## Executive Director's Recommendation

<b>PROJECT</b> <b>Georgetown Canal Plan</b> Chesapeake & Ohio Canal National Historical Park Located between 28 <sup>th</sup> and 36 <sup>th</sup> Streets, NW Washington, DC	<b>NCPC FILE NUMBER</b> 8078
<b>SUBMITTED BY</b> United States Department of the Interior National Park Service	<b>NCPC MAP FILE NUMBER</b> 00:00(00.00)44939
<b>REVIEW AUTHORITY</b> Federal Projects in the District per 40 U.S.C. § 8722(b)(1) and (d)	<b>APPLICANT'S REQUEST</b> approval of comments on concept plans
	<b>PROPOSED ACTION</b> Approve comments as requested
	<b>ACTION ITEM TYPE</b> Staff Presentation

# Georgetown Canal Plan

Approval of Comments on Concept Plans

# Towpath – Option A

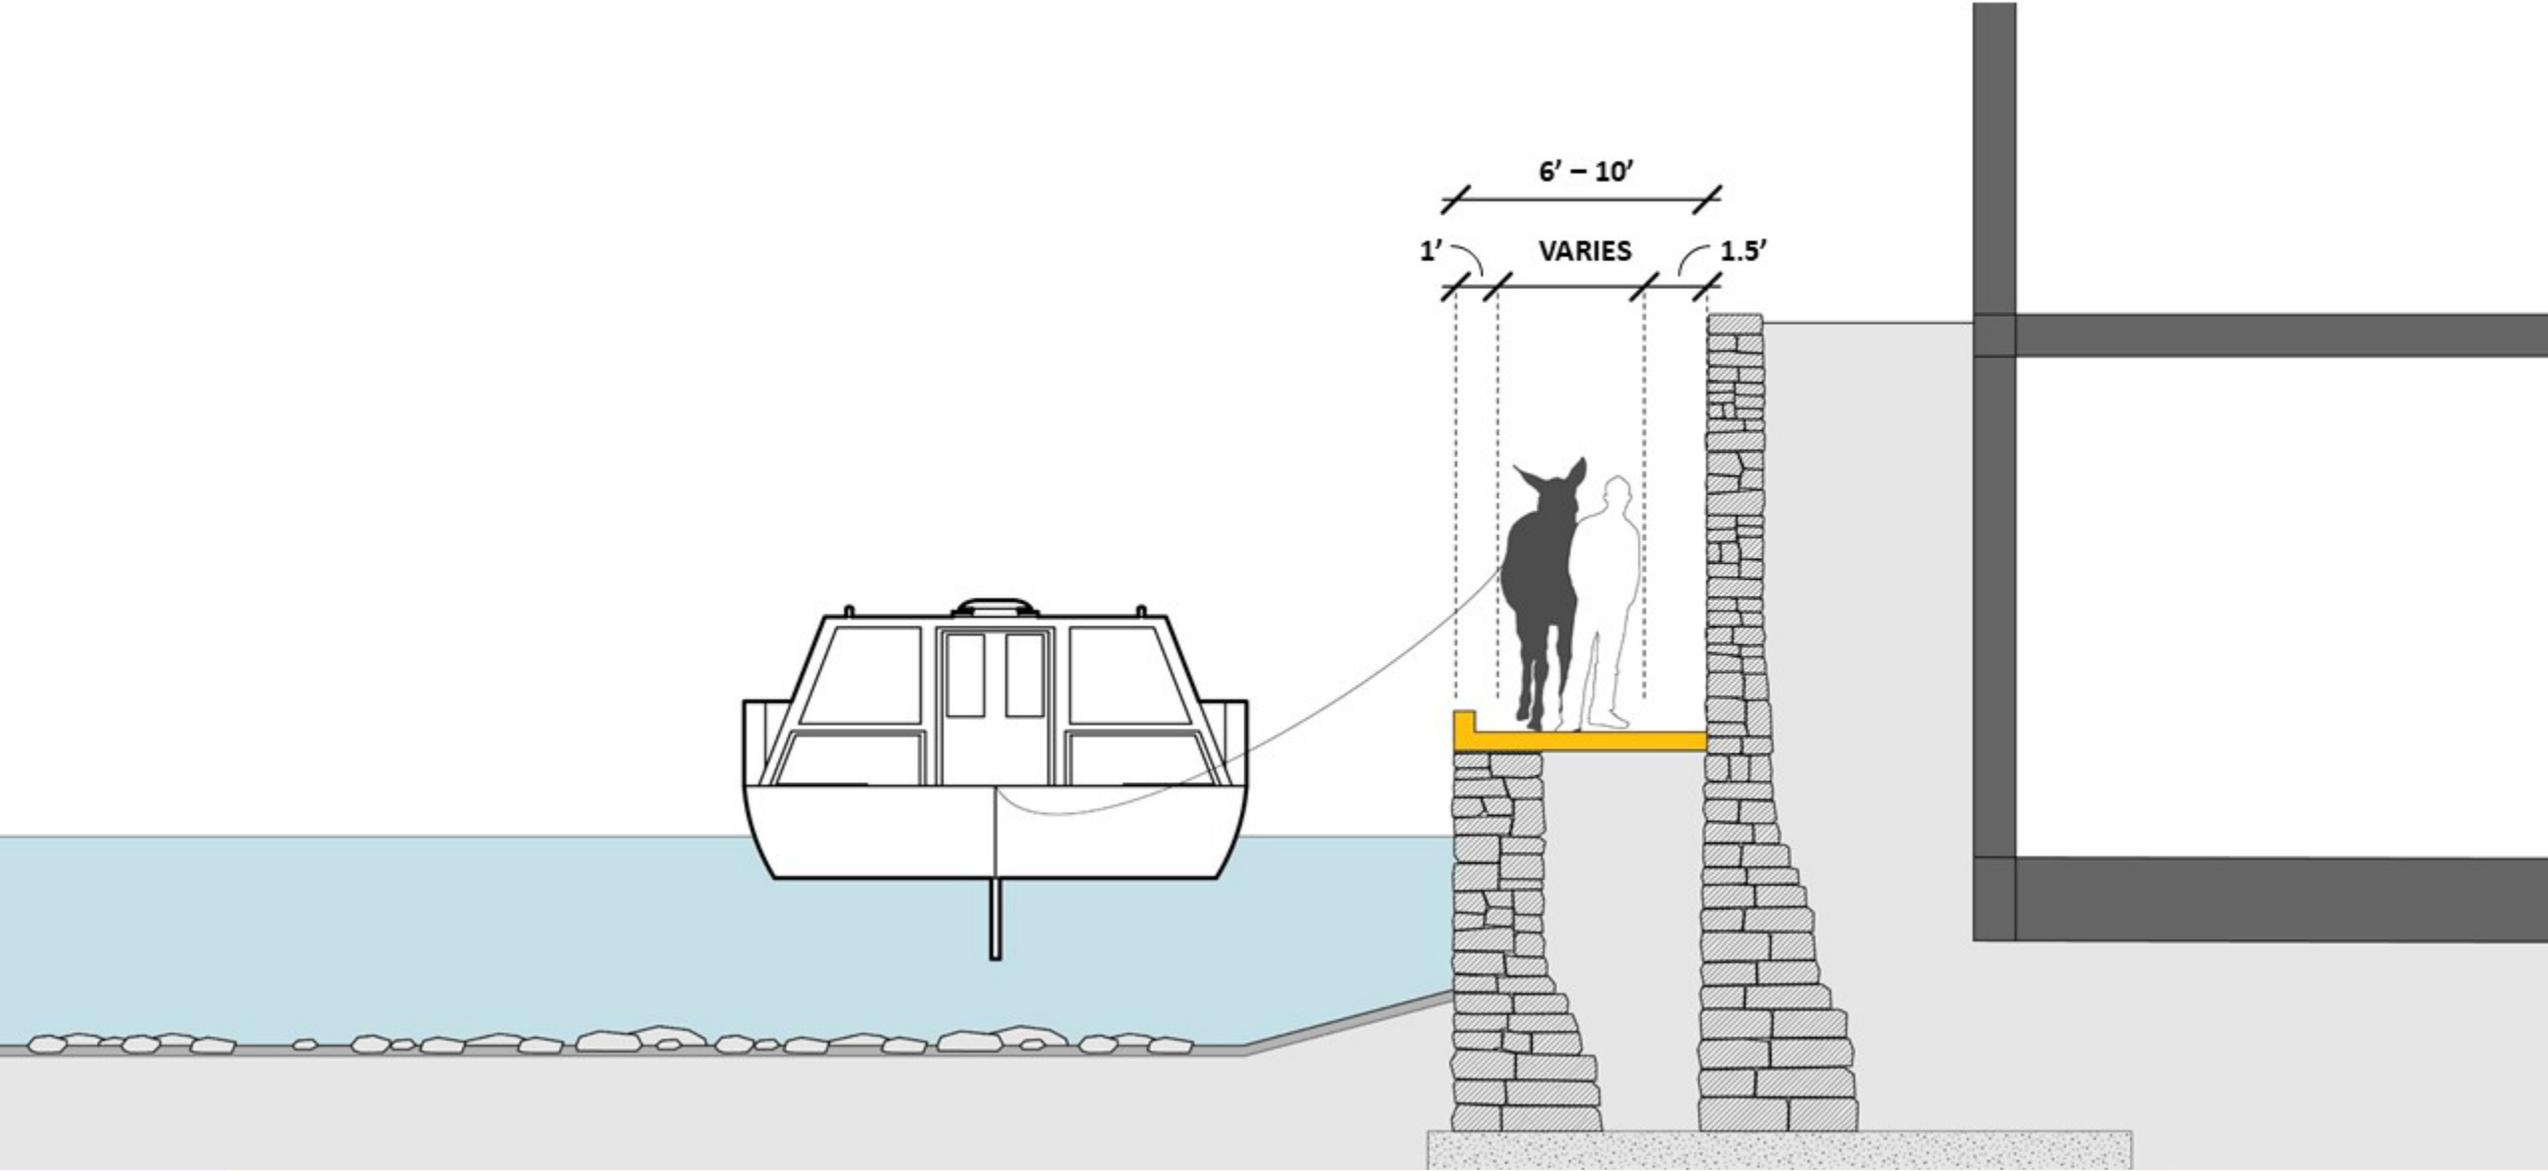
Towpath Option A levels the grade, removes the vegetation, and adds a small curb to the canal edge. This is an acceptable solution for providing additional egress width where the existing towpath does not meet universally accessible (ABAAS-compliant) dimensions.

# Towpath – Option B

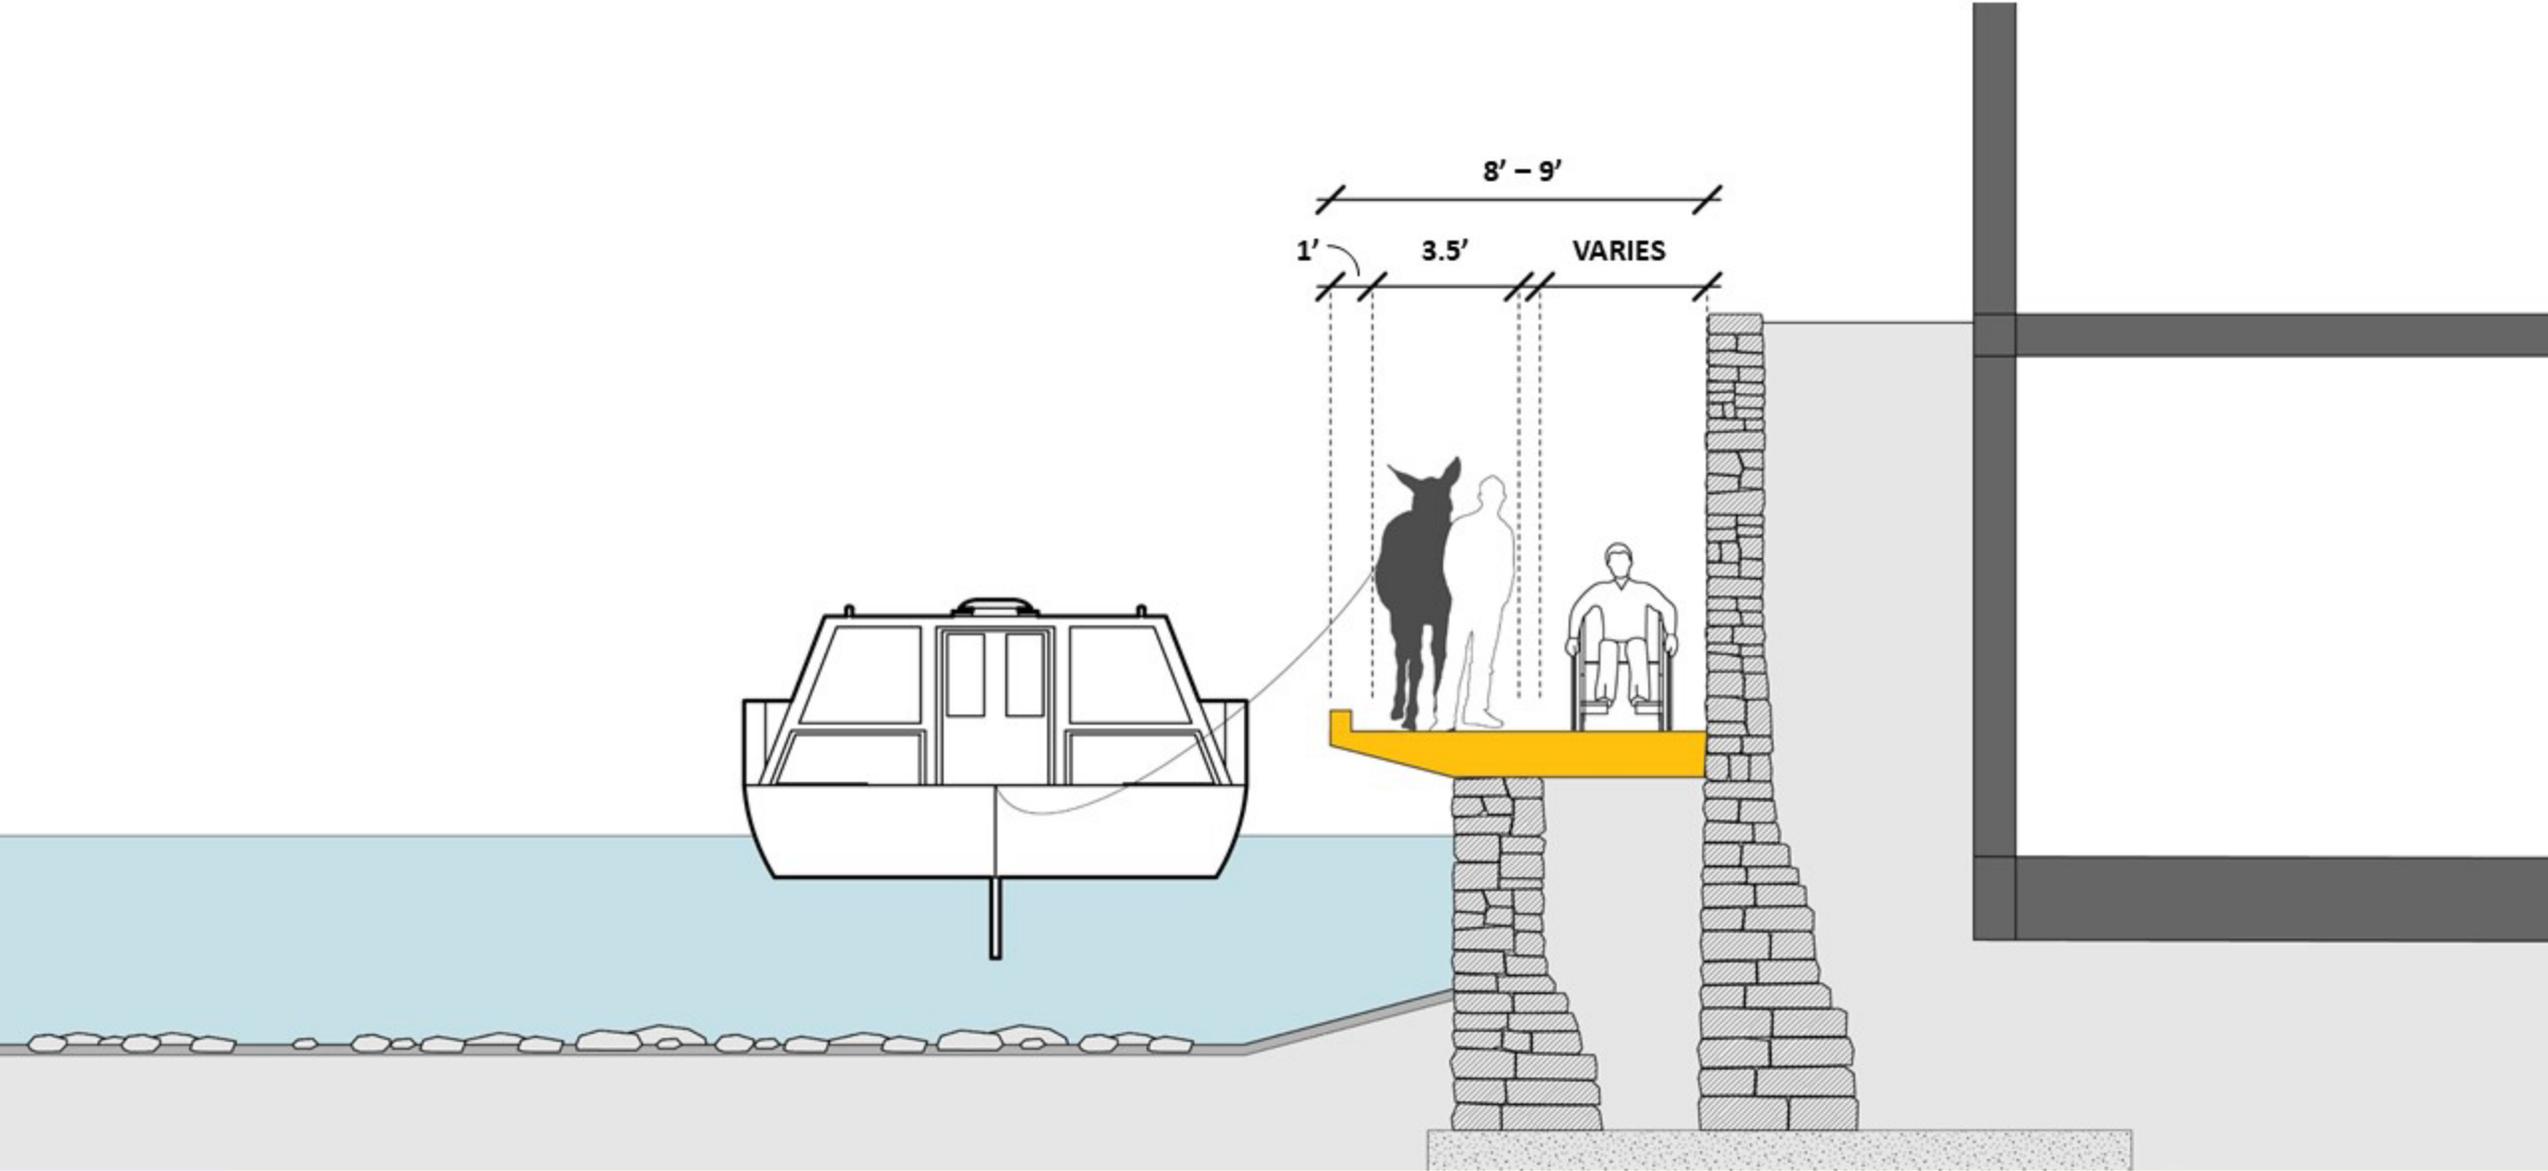
Towpath Option B is similar to Option A, but also cantilevers the walking surface over the canal prism wall in certain locations to be determined, as appropriate. Staff finds that Option B is a dramatic character change that could adversely affect the canal's historic integrity. Staff finds that Option B would not be an acceptable solution for long stretches of the canal. If Option B is necessary for ABAAS-compliance, then the applicant should explore other options including only using Option B in short segments (functioning as a laybys) located in less visible location preferably under bridges so the cantilevers are less noticeable.

# Mile Marker 0 – Option B

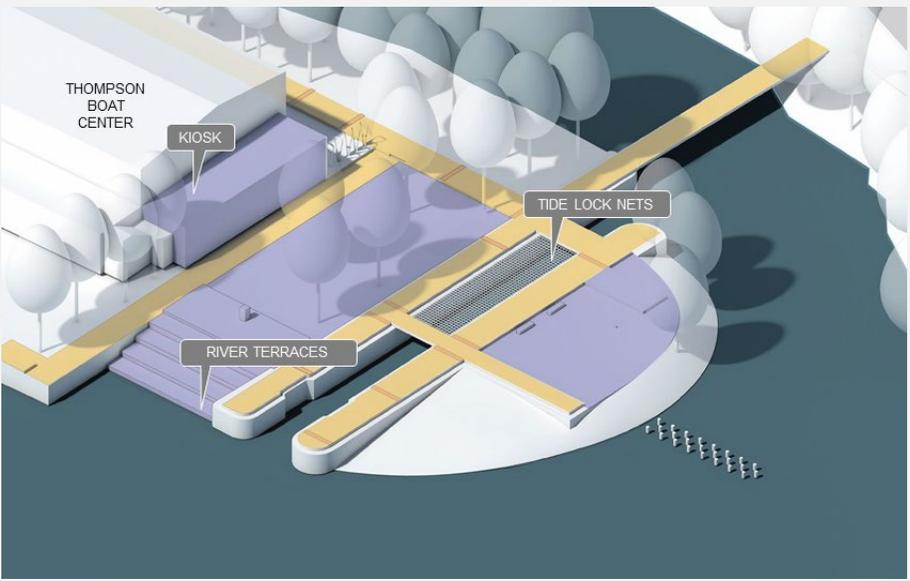
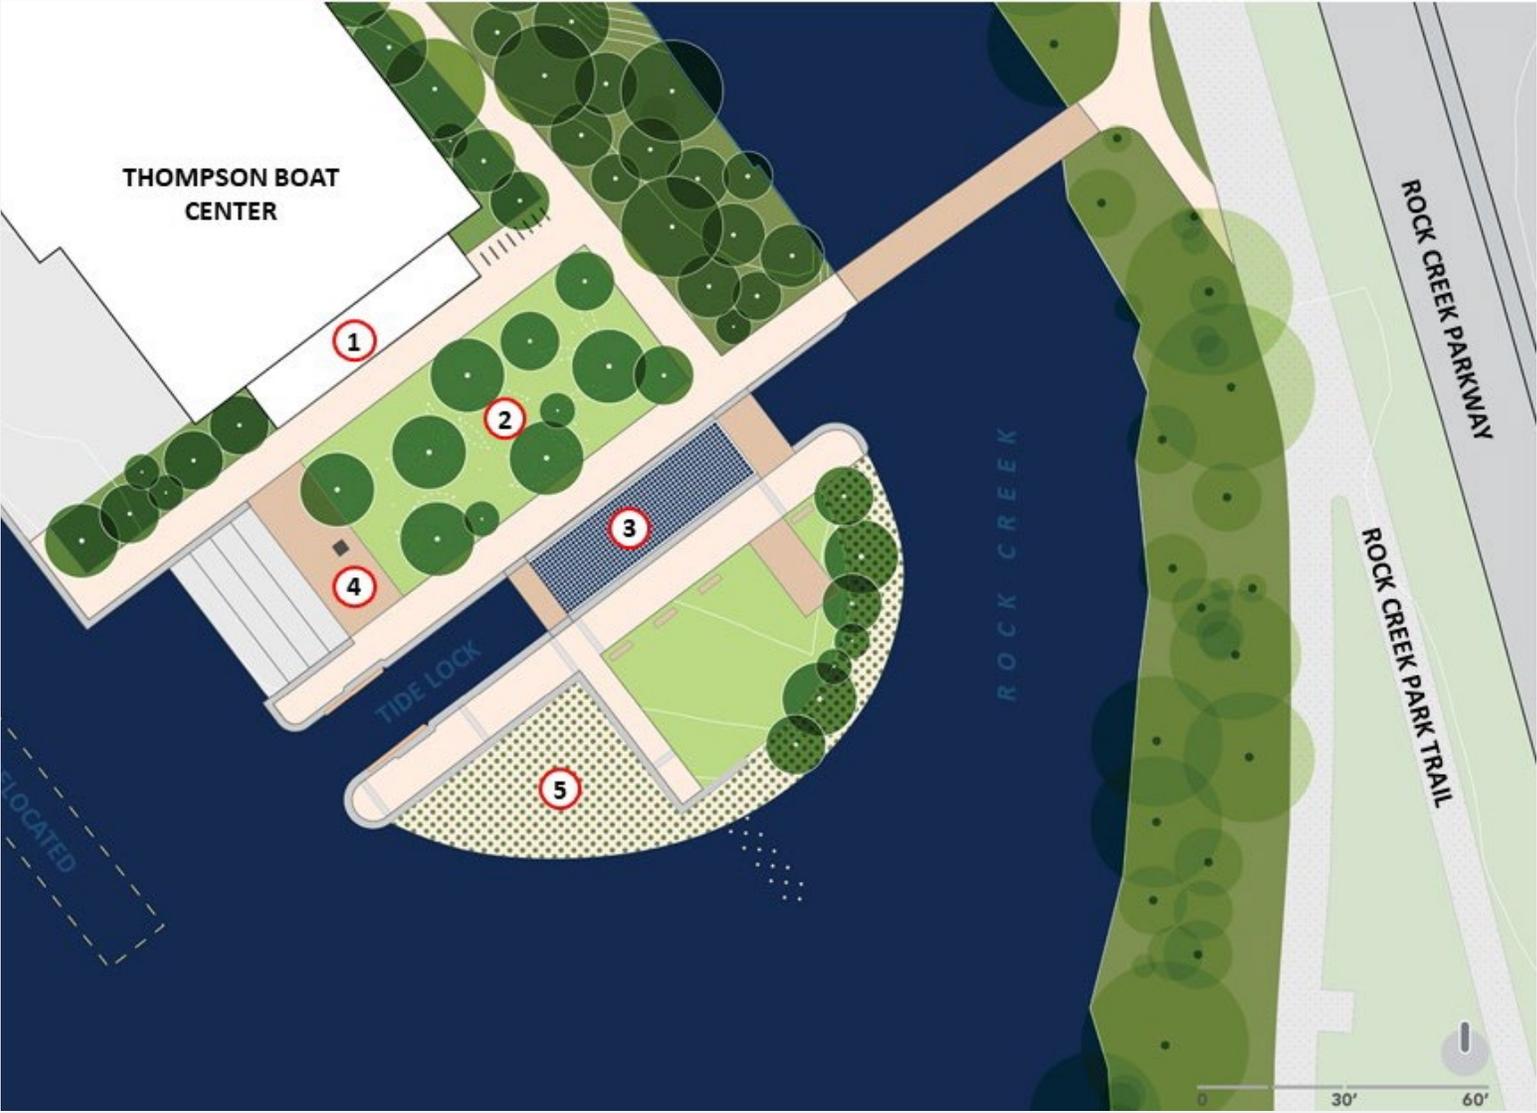
Overall, staff finds that this area can support more significant change, as shown in Option B, and has less potential to impact historic character. Staff supports enhancing trail circulation and access to the Thompson Boat Center and Rock Creek Park Trail while providing waterfront views, as shown in Options A and B, including the Mile Marker 0 Bridge and Potomac Terraces. Staffs finds that Option A follows a very limited approach and misses the opportunity that this site offers as a gathering space for bicyclists and pedestrians. Staff supports Option B's addition of the Mile Marker 0 Platform and relocated boat storage which significantly improves the quality of open

space around this gateway location and increases the site's tree canopy. Staff supports Option B's provision of a more attractive gathering places with views to Roosevelt Island and the Kennedy Center. Staff also supports providing terraces to engage the water's edge. However, staff questions the success of the Tide Lock Nets and suggests the applicant further consider this element.

# Rock Creek Confluence – Option A

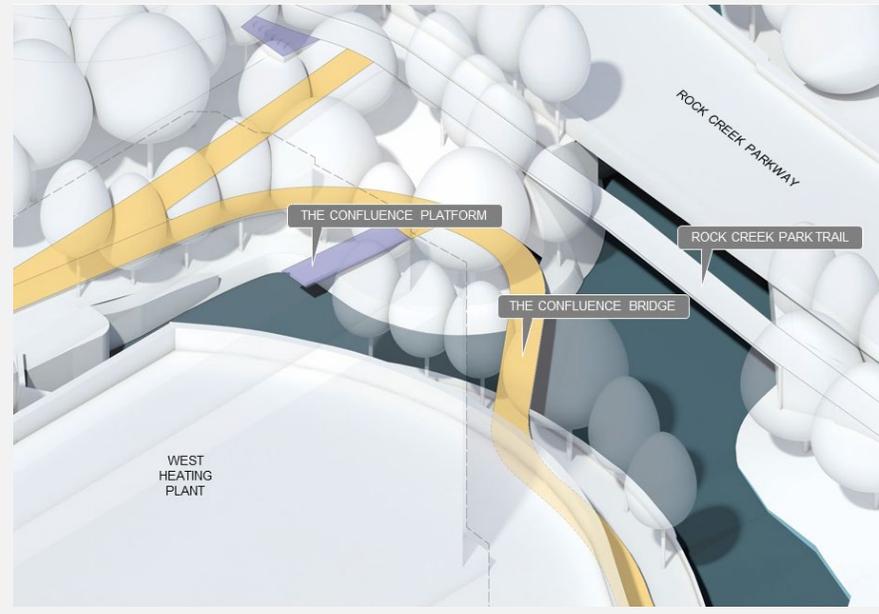
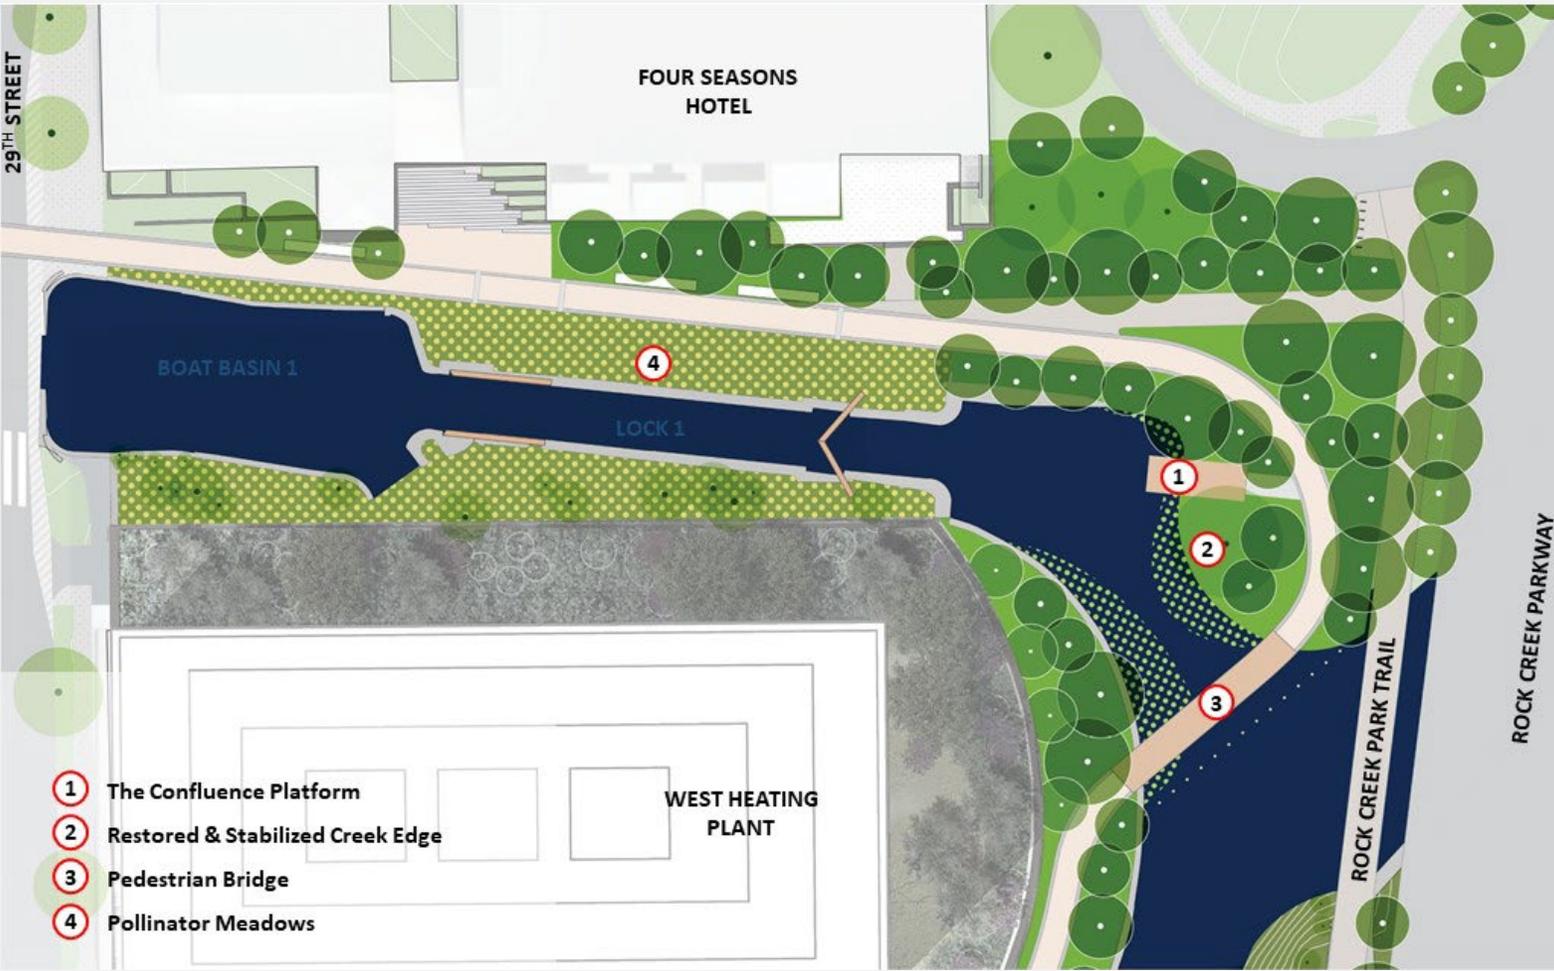
Overall, staff finds that this area can support minimal change, as shown in option A, and has more potential to impact historic character. Staff notes that Option A (the only option presented) provides a connection to privately owned land occupied by the West Heating Plant. Staff supports this connection, which is distanced from the traffic and noise along Rock Creek and Potomac Parkway. Staff encourages the applicant to work with the West Heating Plant landowner to ensure private lands are publicly accessible to trail users. Staff also recommends that the applicant evaluate how the Confluence Bridge would be impacted by flood events and consider the C&O Canal Potomac River Flood Response Plan.
